Amendments to the Drawings

Appl. No. 10/657,025  
Amdt. Dated September 21, 2004  
Reply to Office Action of July 8, 2004  
Annotated Sheet Showing Changes

**FIG. 6**

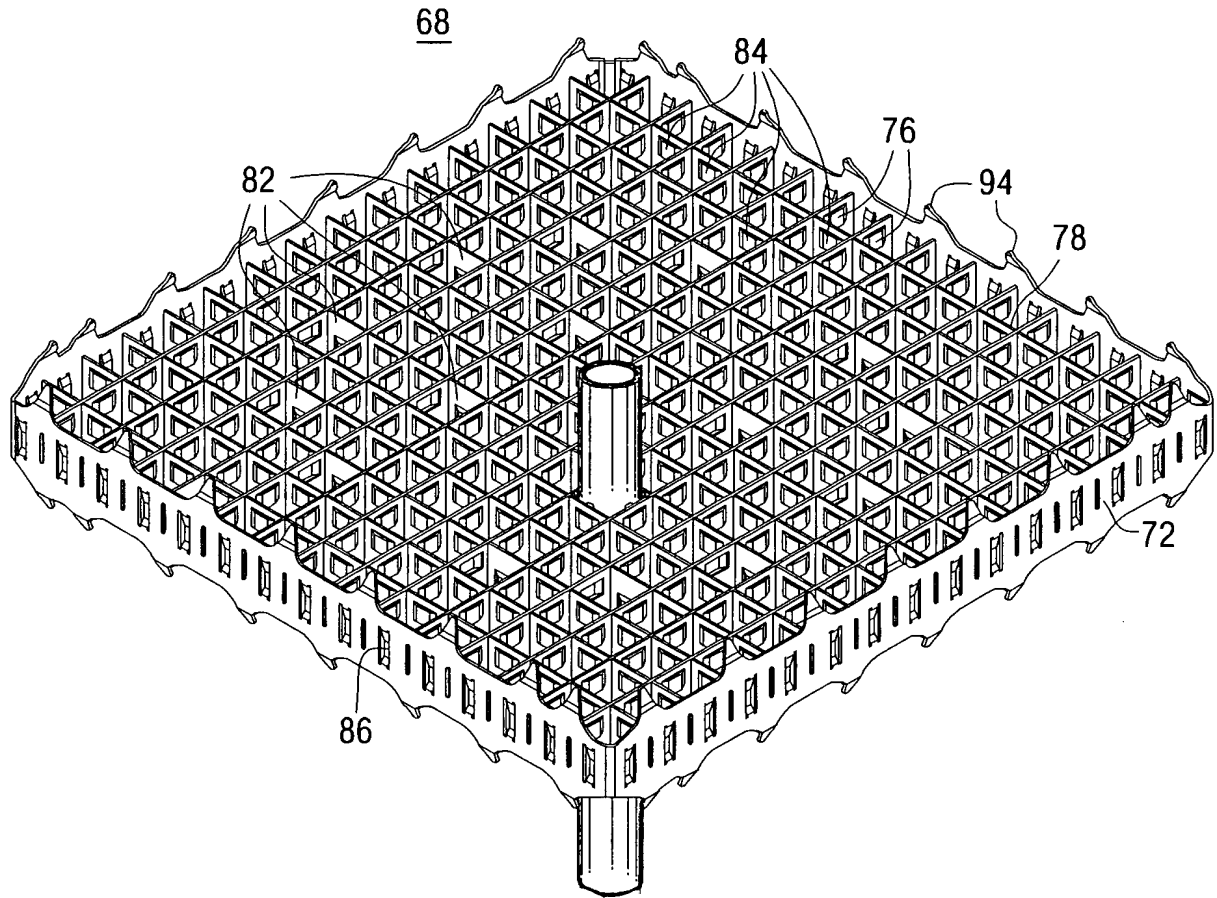
The drawings are objected to under 37 CFR 1.83(a). The Examiner asserted that the drawings must show every feature of the invention specified in the claims; asserting that Claims 8, 9 and 13 must be shown or the features cancelled from the claims.

Claim 9 calls for the fuel assembly of Claim 8 wherein the dimples and/or springs on the walls of the respective auxiliary grid support cells are co-planar. Referring to Figure 6, it can clearly be seen that a common plane intersects both the vertical springs and the dimples, which is not the case in the main support grid design.

Claim 13 recites that the auxiliary grid is mechanically or metallurgically affixed to at least some of the guide tubes. The amended Figure 6 clearly shows the guide tube through an auxiliary grid attached at the cell corners by butt-welds. Accordingly, amended Claim 6 should cure the Examiner's objections to the drawings.

The attached sheet of drawings include changes to Figure 6. This sheet, which includes Figure 6, replaces the original sheet including Figure 6. In Figure 6, the previously omitted control rod guide tube showing corner welds to the grid cell has been added. Support for this addition may be found on page 11, starting at line 9 et sec.
